Access Compliance Report

Public Rights-of-Way

(Curb Ramps)

Intersection ID: 28626	Main Street: MILLERS_CREEK_LN	Cross Street: STUARTS_DRAFT_CT	Location: SW
ADA ID: D5F21147616B	Ramp Type: PerpDiag	Initial Pass/Fail: Fail	Overall Compliance: No
Severity Score: 22.5			
Codes/Mitigation Info/Possible Solution		Field Measurements/Component Compliance

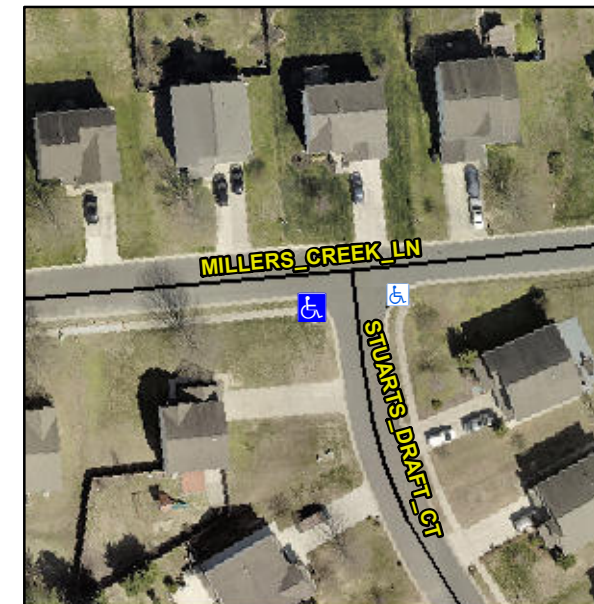
R304.5.1, R304.2.2, R304.5.3

Compliance	Description	Data	Compliance	Description	Data
N/A	Ramp Length (in)	48.3	No	Ramp Slope (%)	8.5
No	Ramp Width (in)	39.0	No	Ramp XSlope (%)	4.6
N/A	Flare Type LT	N/A	N/A	Flare Type RT	N/A
N/A	Flare Slope LT (%)	N/A	N/A	Flare Slope RT (%)	N/A
N/A	Flare Traversable LT?	N/A	N/A	Flare Traversable RT?	N/A
N/A	Landing Length (in)	N/A	N/A	DWS Provided?	N/A
N/A	Landing Width (in)	N/A	N/A	DWS Contrast?	N/A
N/A	Landing Slope (%)	N/A	N/A	DWS Length (in)	N/A
N/A	Landing X Slope (%)	N/A	N/A	DWS Full Width?	N/A
N/A	Landing Curb? (Y/N)	N/A	N/A	DWS Offset (in)	N/A
N/A	Shared Landing?	N/A			
N/A	Gutter Ponding?	N/A	N/A	Gutter Slope (%)	N/A
N/A	Gutter Lip Ht (in)	N/A	N/A	Gutter X Slope (%)	N/A
N/A	Painted X Walk1?	No	N/A	Painted X Walk2?	No
	X Walk 1 Direction	To E		X Walk 2 Direction	To N
N/A	X Walk 1 Width (in)	N/A	N/A	X Walk 2 Width (in)	N/A
	X Walk 1 Slope (%)	2.8		X Walk 2 Slope (%)	3.0
	X Walk 1 X Slope (%)	4.3		X Walk 2 X Slope (%)	1.2

Remove & Replace Curb Ramp With Two New Directional Ramps or Equivalent.
